7.0 Instrumentation and Control Systems

7.1 Introduction

The information in this section of the reference ABWR DCD, including all subsections and tables, and figures, is incorporated by reference with the following departures and supplements.

Figure 7.1-1 ~~SSLC Self-Test System~~ Diagnosis

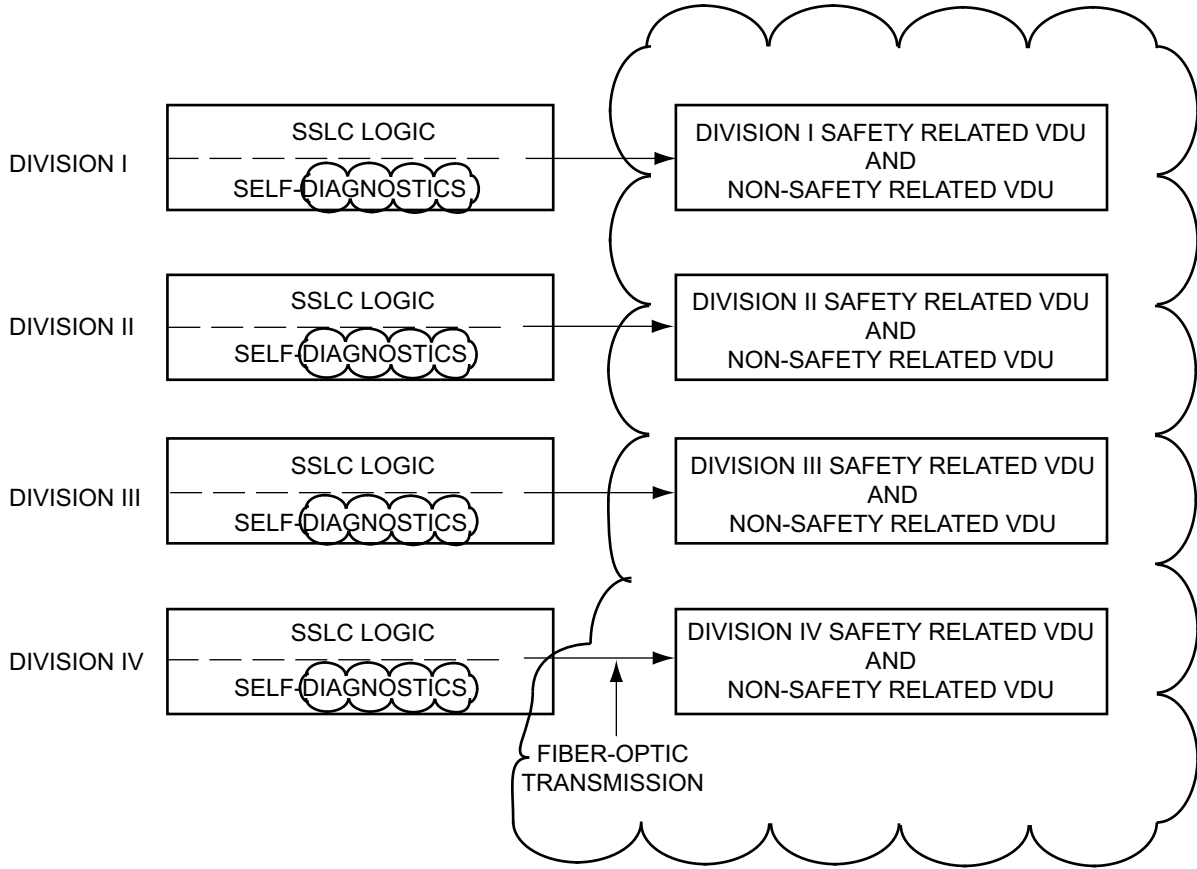
STD DEP T1 3.4-1 (Figure 7.1-1, 7.1-2)

STD DEP T1 3.4-1

Each individual safety-related system utilizes redundant channels of safety-related instruments for initiating safety action. The automatic decision making and trip logic functions associated with the safety action of several safety-related nuclear steam supply systems (NSSS) are accomplished by ~~a four-division correlated and separated protection logic complex called the safety system logic and control (SSLC)~~. The SSLC includes multiple redundant divisions, which are separated from each other. The SSLC has four redundant divisions of sensors. Each division of sensors has a corresponding division that determines the trip status of the safety functions relative to the safety function setpoint. The SSLC has four redundant divisions for all actuation functions except for the engineered safety features. The engineered safety features have three divisions, corresponding to the maximum redundancy of the engineered safety features actuated components. Some engineered safety features functions are less than three-fold redundant and are assigned to the appropriate set of redundant divisions. The SSLC multi-divisional complex includes divisionally separate control room and other panels which house the SSLC equipment for controlling the various safety function actuation devices. The SSLC receives input signals from the redundant

Figure 7.1-2 Assignment of Interfacing Safety System Logic to SSLC Controllers

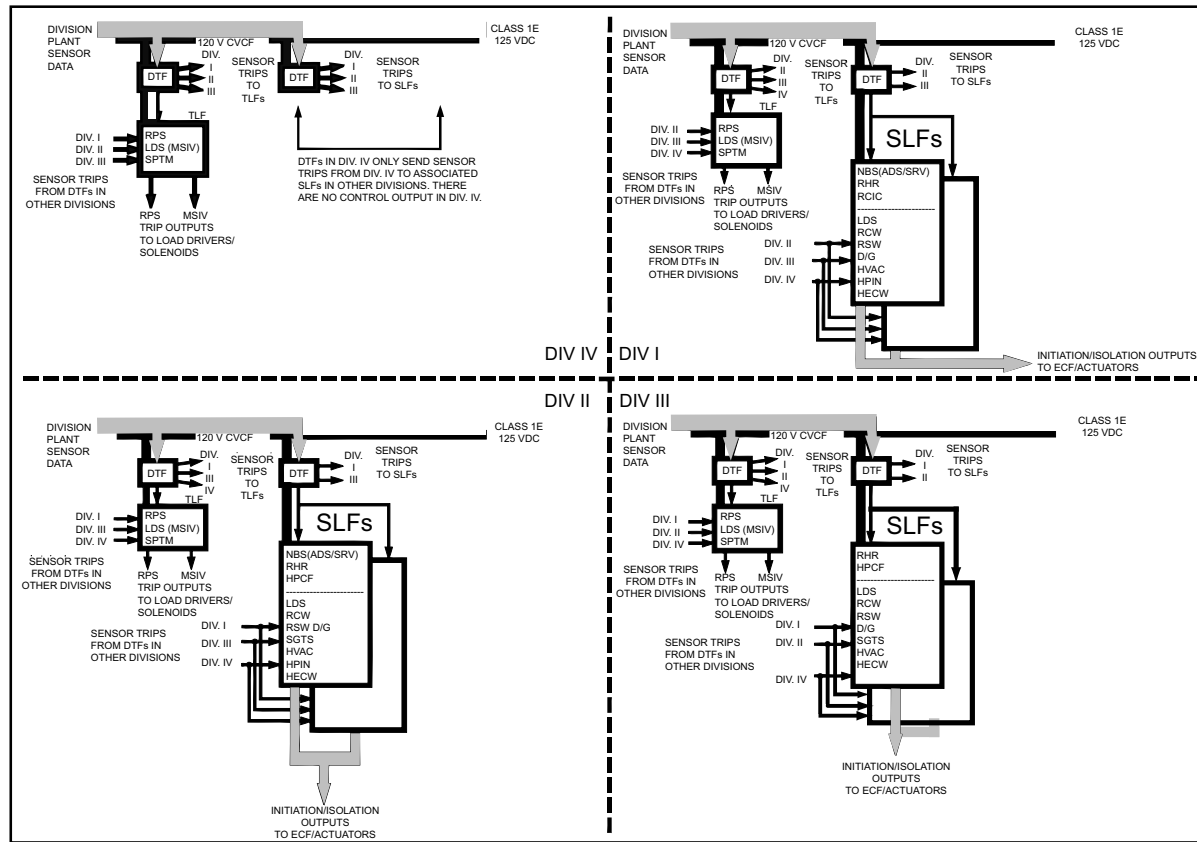
~~Divisional separation is also applied to the essential multiplexing system (EMS), which provides data highways for the sensor input to the logic units and for the logic output to the system actuators (actuated devices such as pump motors and motor operated valves). Systems which utilize the SSLC are include: (1) Reactor Protection (trip) System; (2) High Pressure Core Flooder System; (3) Residual Heat Removal System; (4) Automatic Depressurization System; (5) Leak Detection and Isolation System; (6) Suppression Pool Temperature Monitoring System; and (7) Reactor Core Isolation Cooling System. The equipment arrangement for these systems and other supporting systems is shown in Figure 7.1-2.~~
